Application for Certification (15-AFC-01)

Puente Power Project (P3)
Oxnard, CA

Responses to City of Oxnard Data Requests Set 4

December 2015

FIGURE 86-1

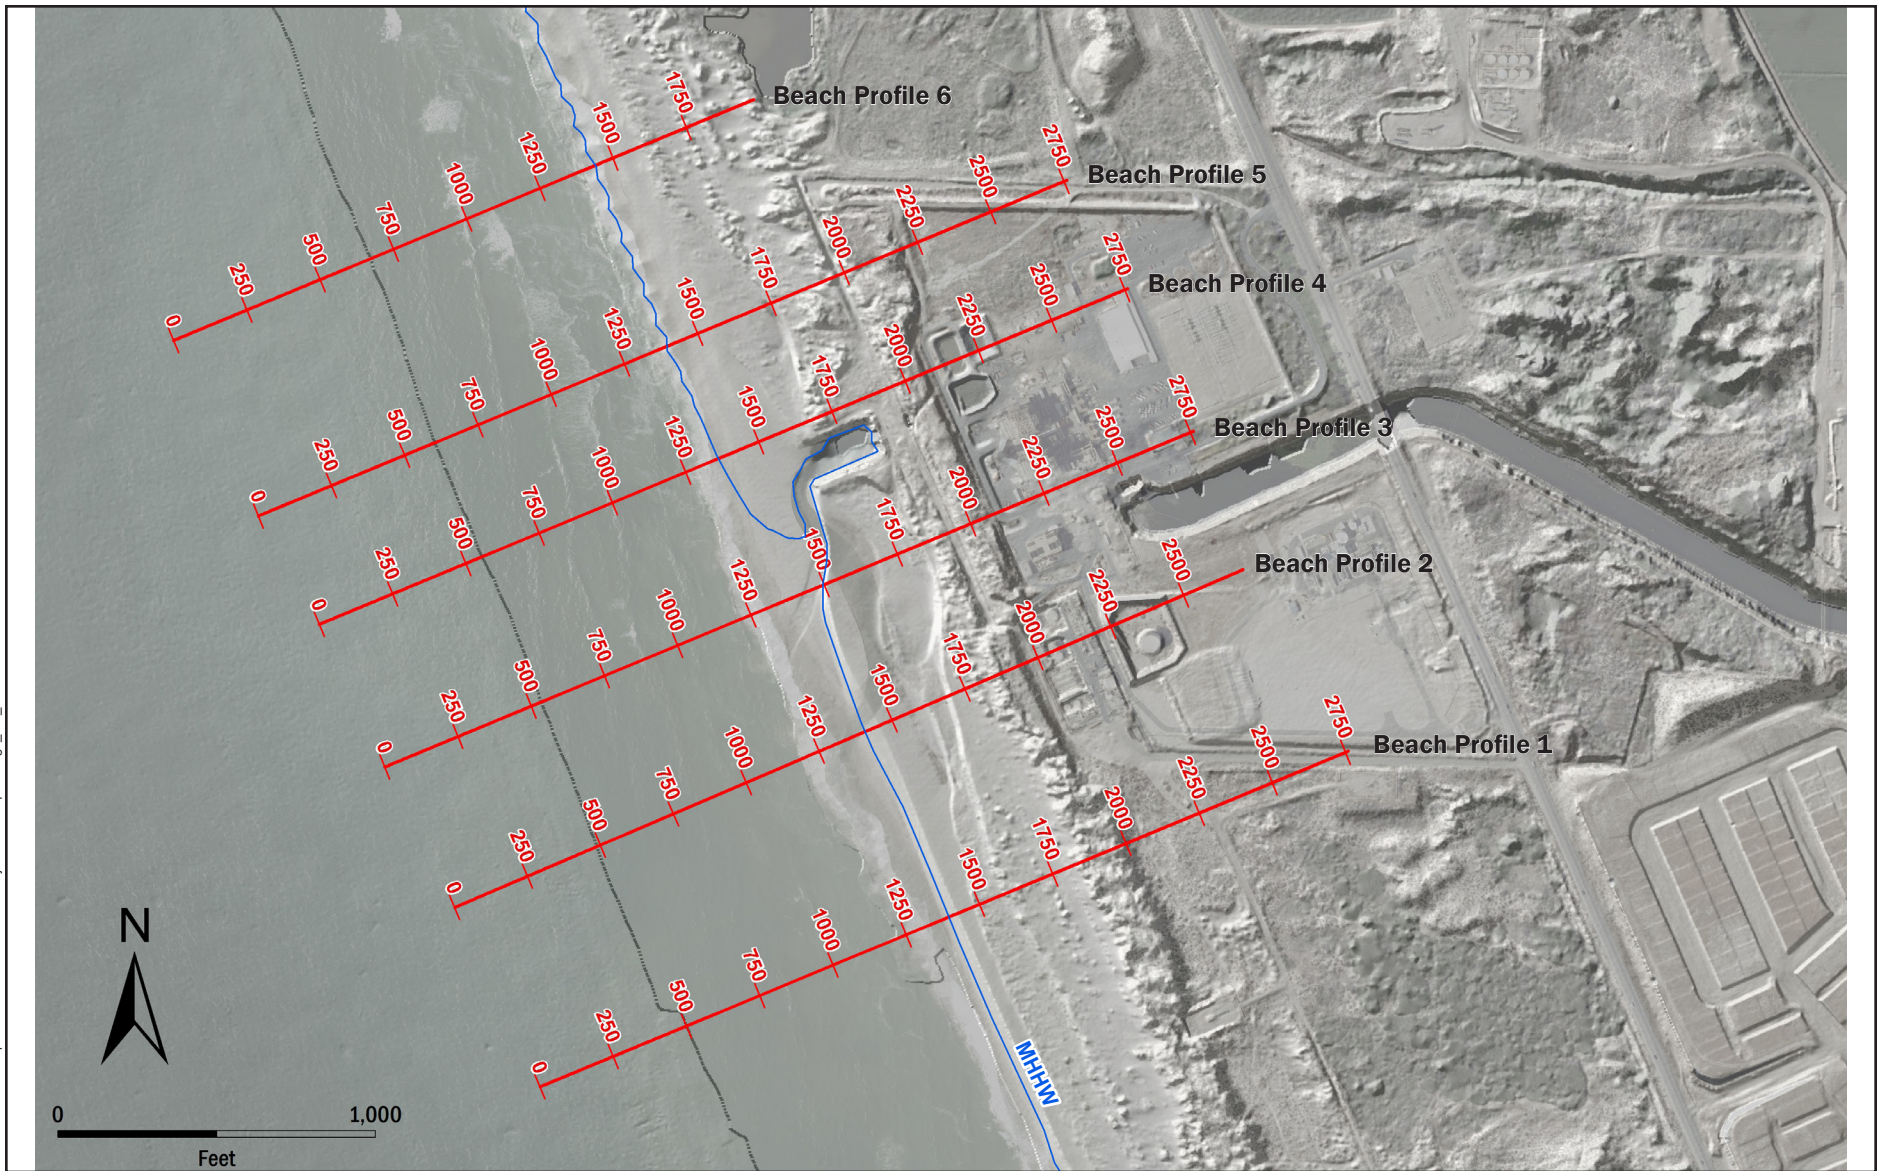
- 86. *Some of the figures included in the applicant's responses lack information that is necessary to interpret these figures. Please identify the source of the topographic data used in Figure 54-2. Please also reproduce Figure 56-1 with a legend describing the data points.***

Figure 56-1 used symbol types to distinguish photos that were included in the Application for Certification (AFC) Appendix N-2 (TN# 204220-14) and the additional photos that were included with the response to Data Request 64 (TN # 206310). As requested, Figure 56-1—with a legend describing the data points—is provided as Figure 86-1.

FIGURE 87-1

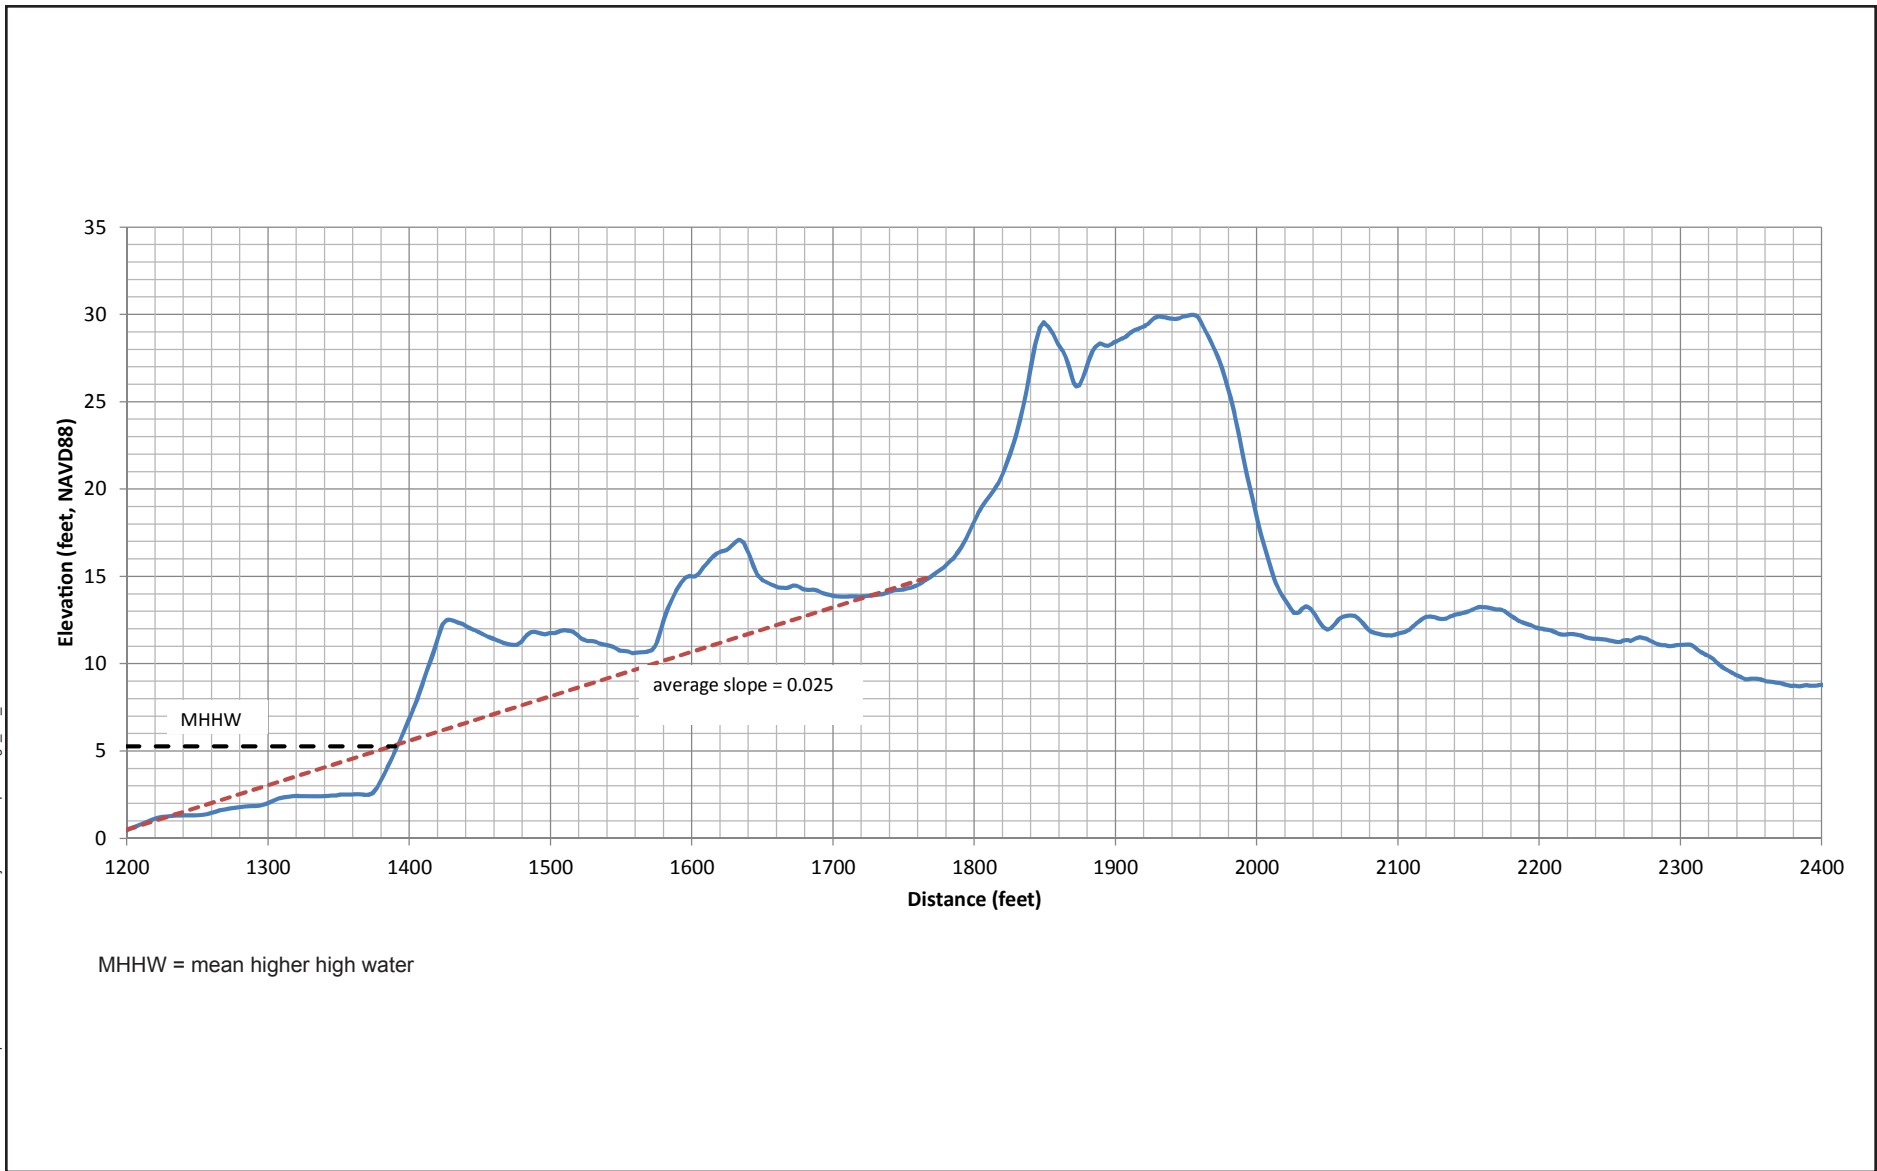
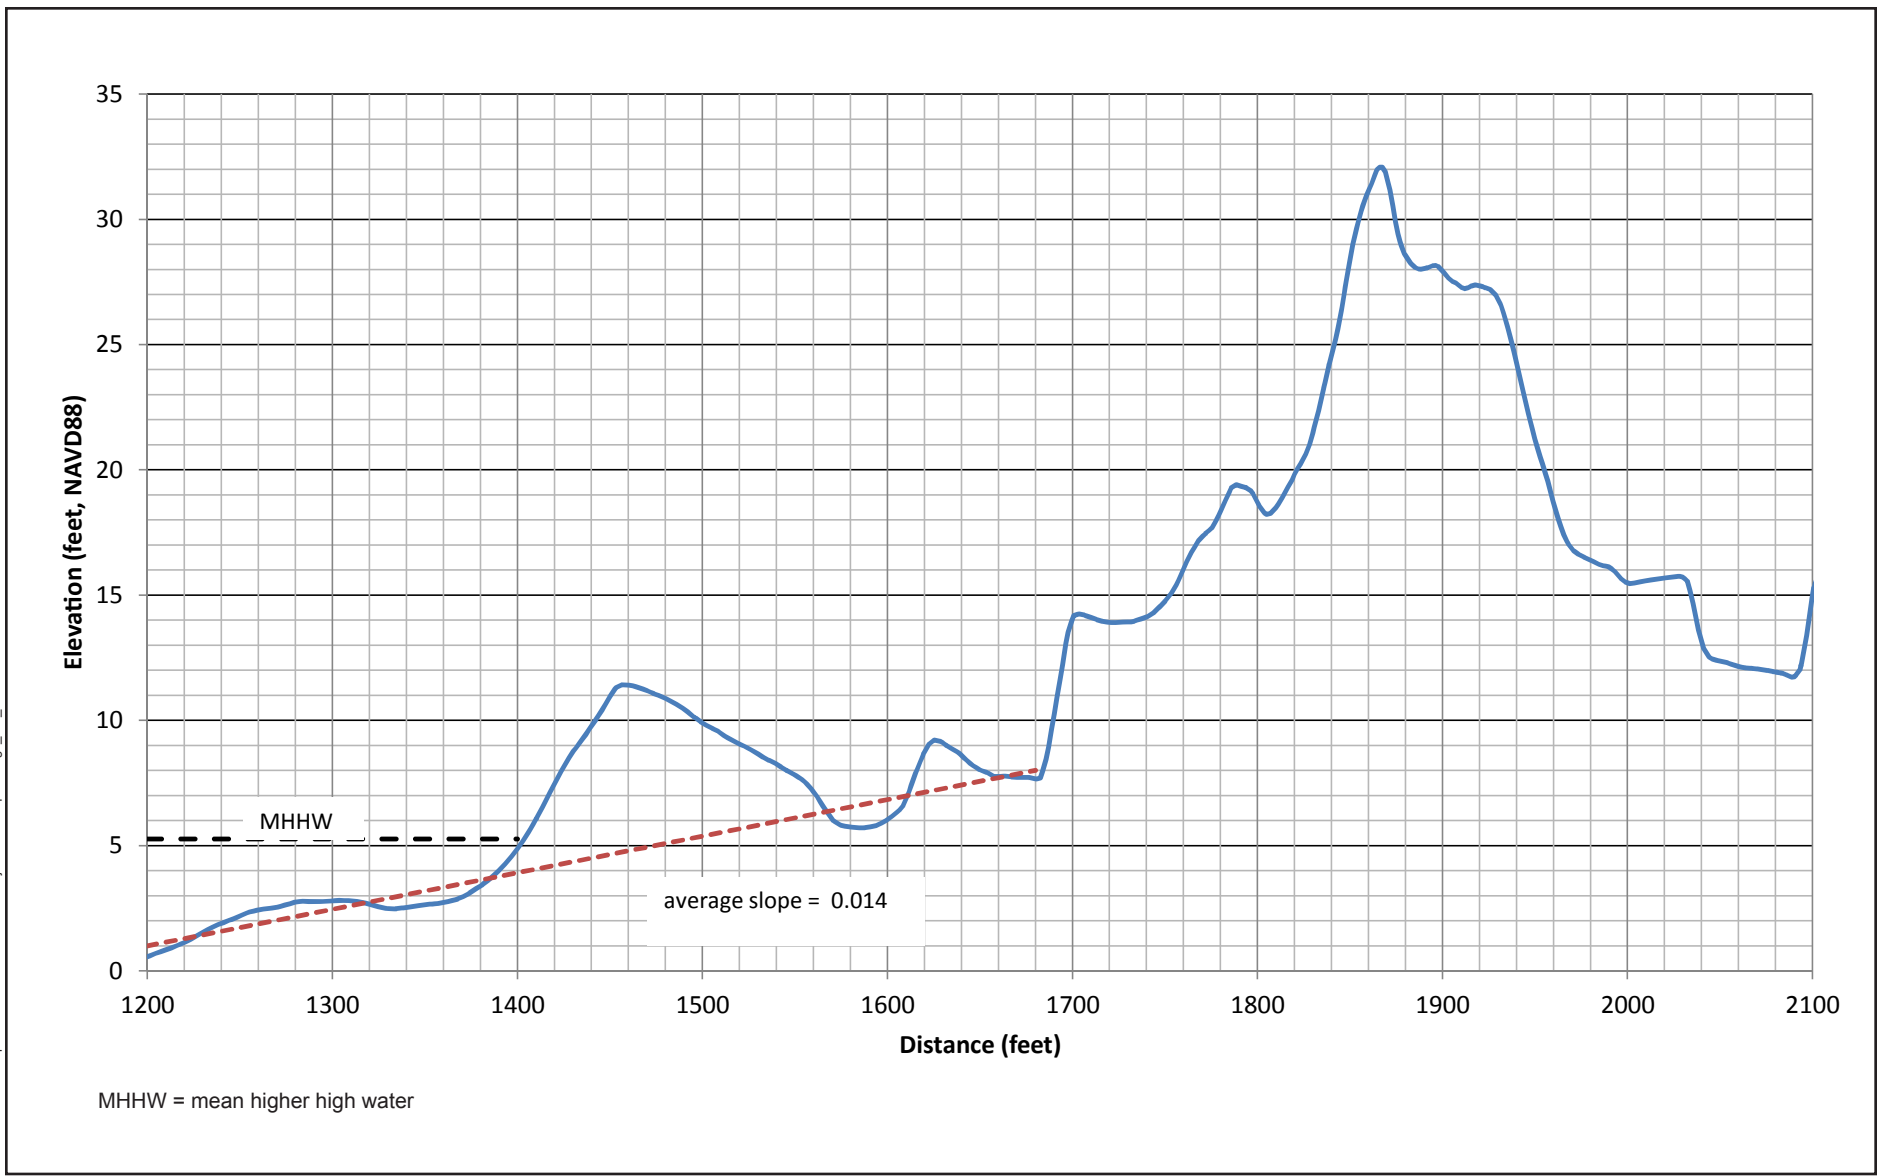
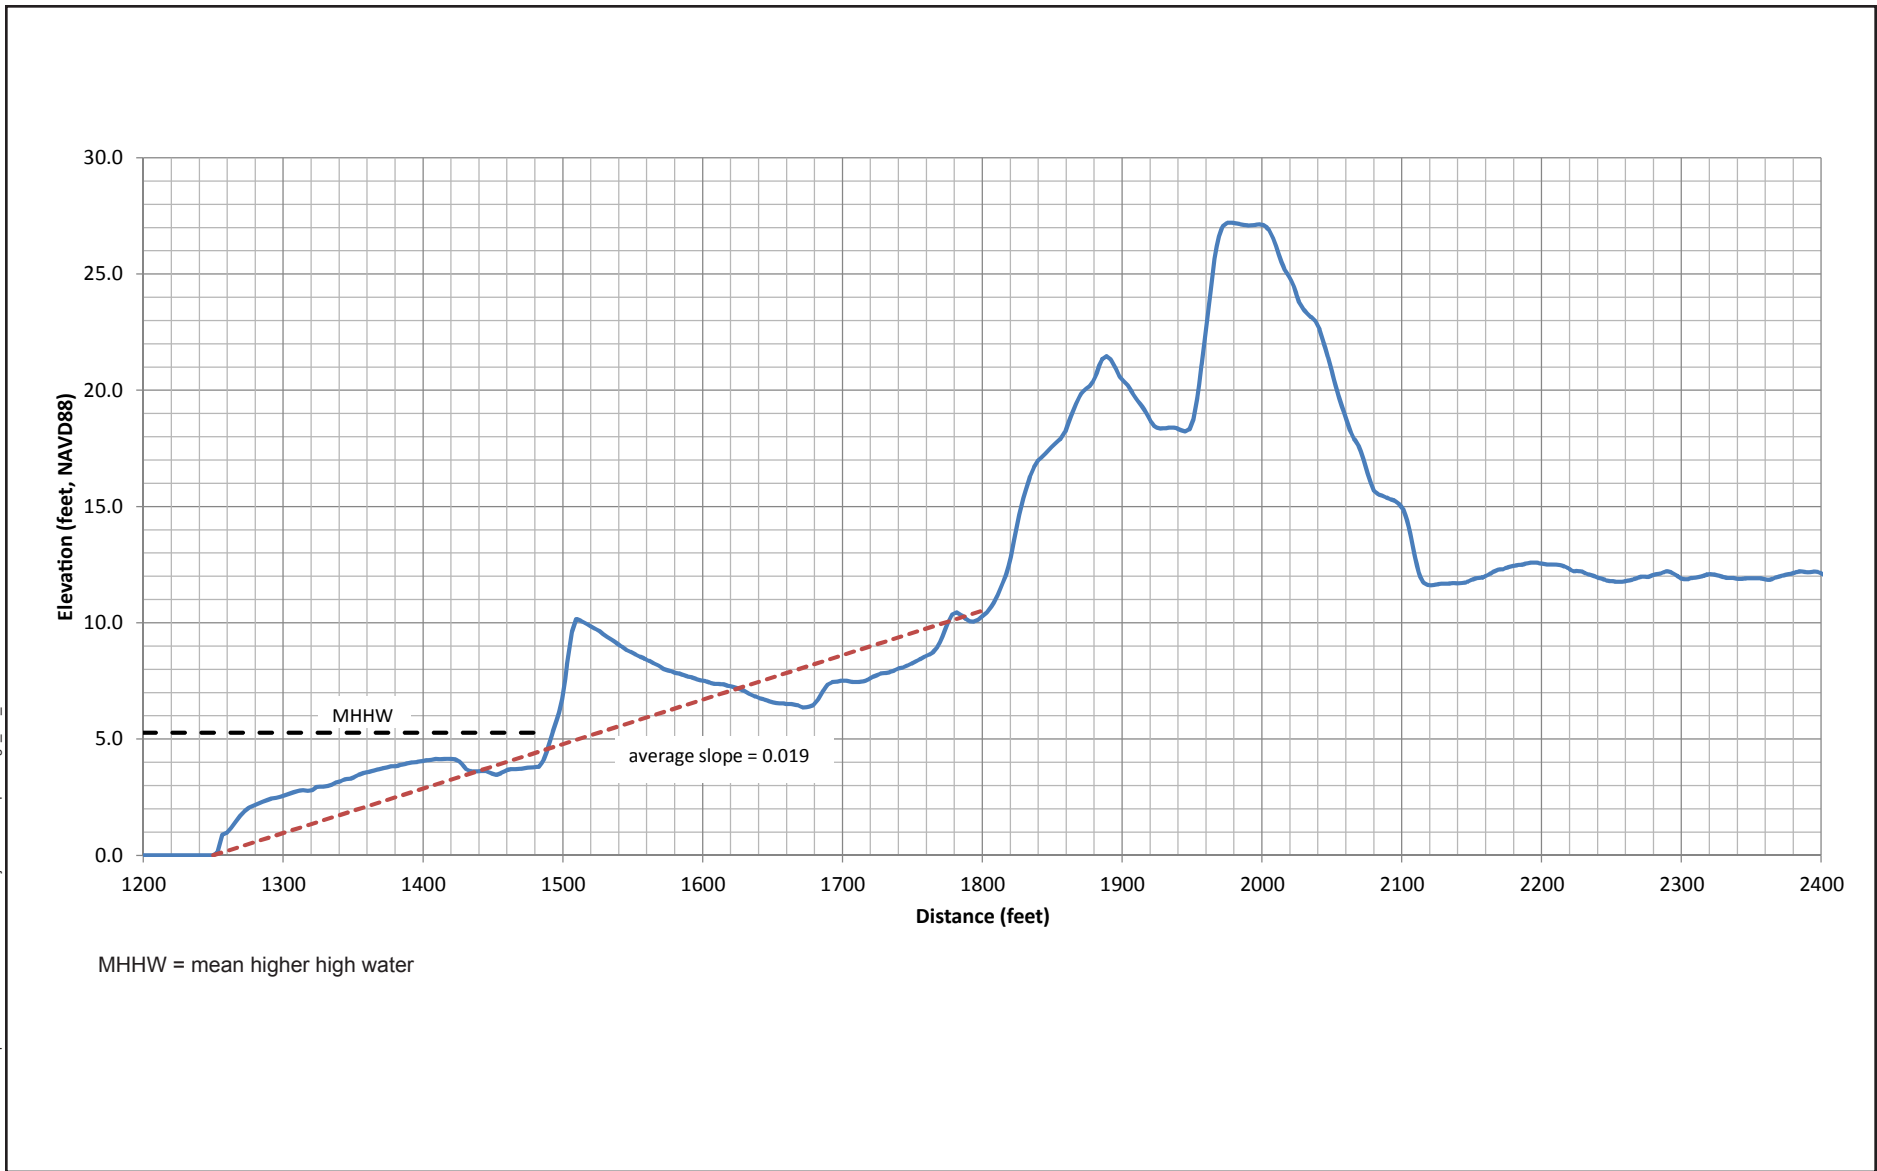
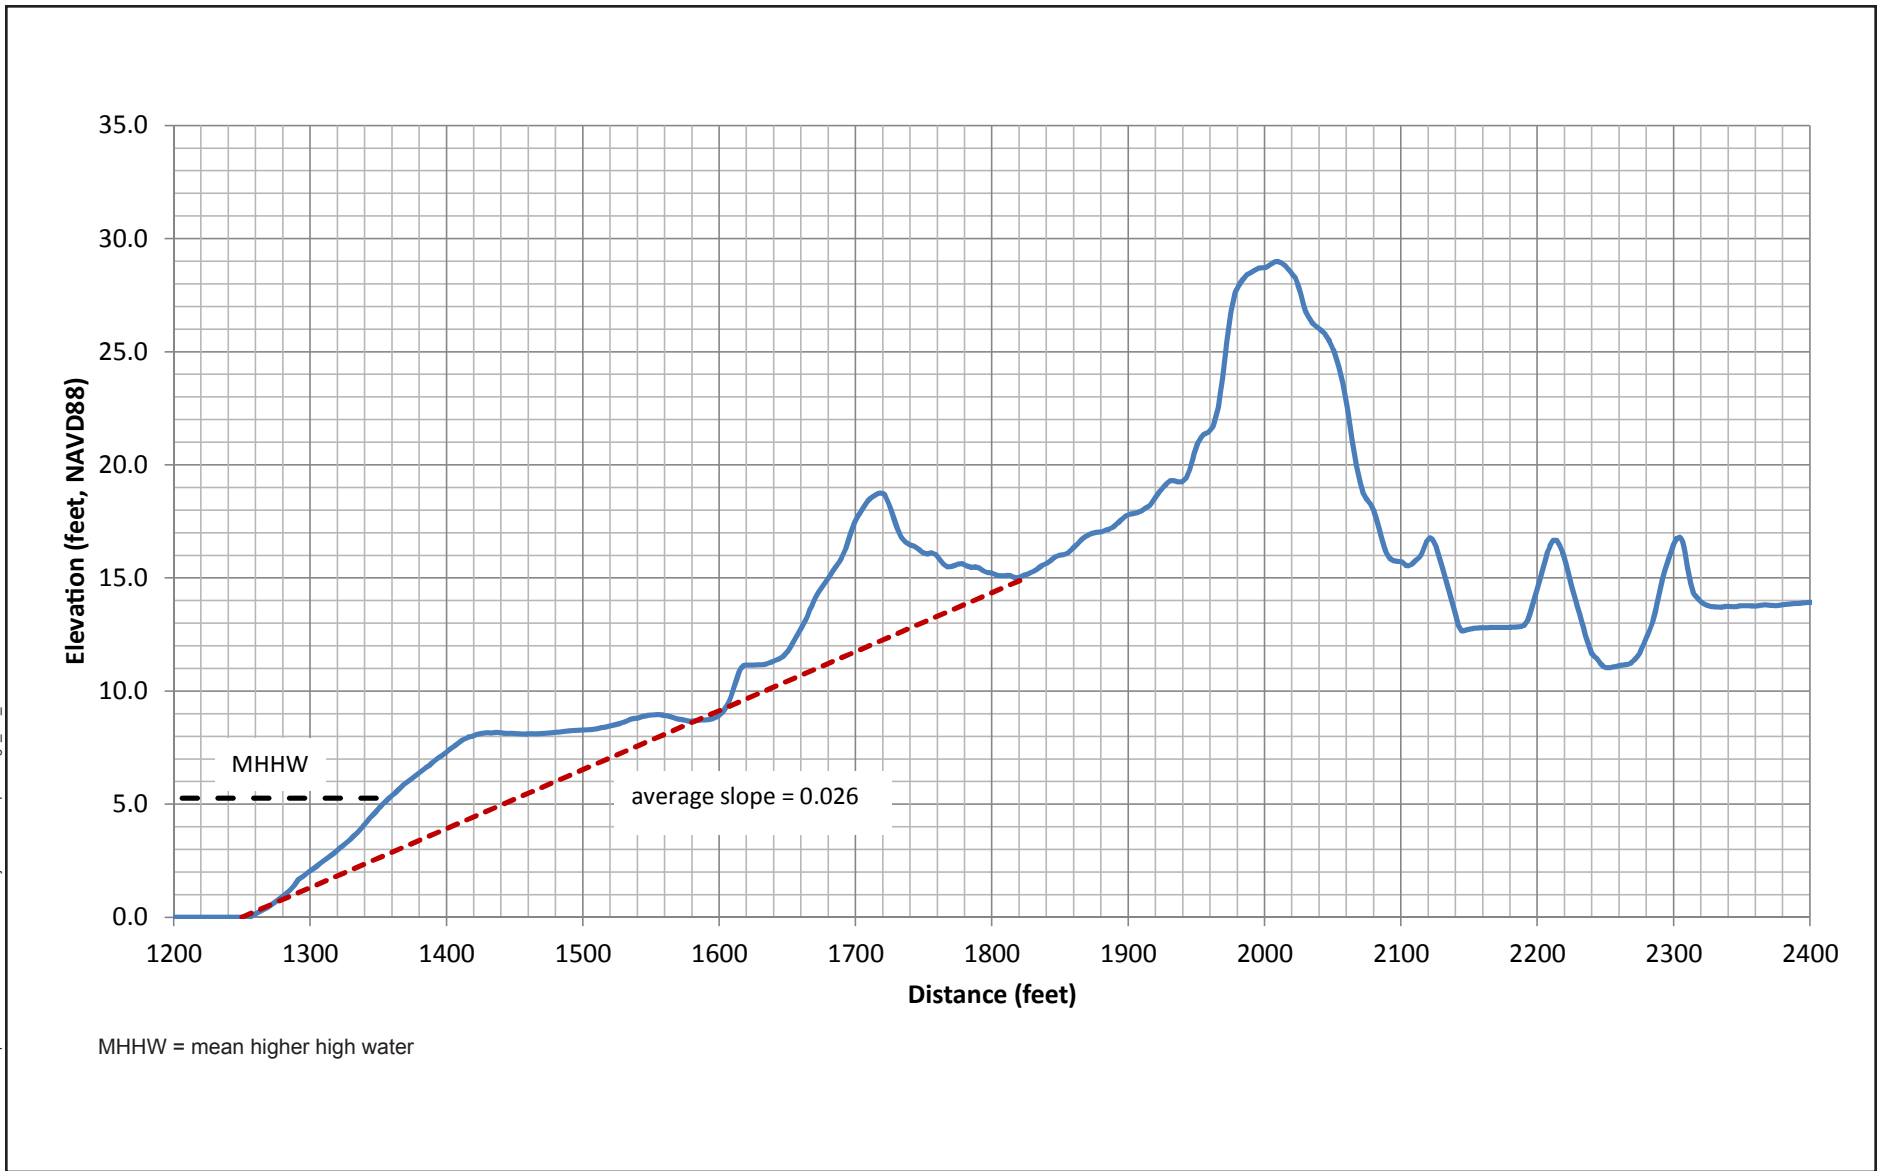
- 87. The applicant's responses to the City's Data Requests, Set 2 mention an average slope of Mandalay Beach calculated using beach profiles obtained from the 2013 LiDAR data. Please provide the beach profiles used to calculate the average slope of Mandalay Beach.**

Six profiles were developed from the most currently available LiDAR data. It should be noted that the LiDAR data were published in 2013, but the data are from 2009-2011, as explained in the response to Data Request 84. The locations of the profiles are shown on Figure 87-1. The individual profiles are shown on Figures 87-2 through 87-7. Figure 54-1 shows the idealized beach dune system assumed for calculation of dune erosion using the method described in Komar et al. (1999). The average beach slopes shown on Figures 87-2 through 87-7 were selected to be consistent with the conservative Komar et al. (1999) method, as explained in the response to Data Request 54. The average beach slope is approximately 3 percent, based on the six profiles. The LiDAR data used to compute the beach slopes for each profile are provided in Appendix 87-1.
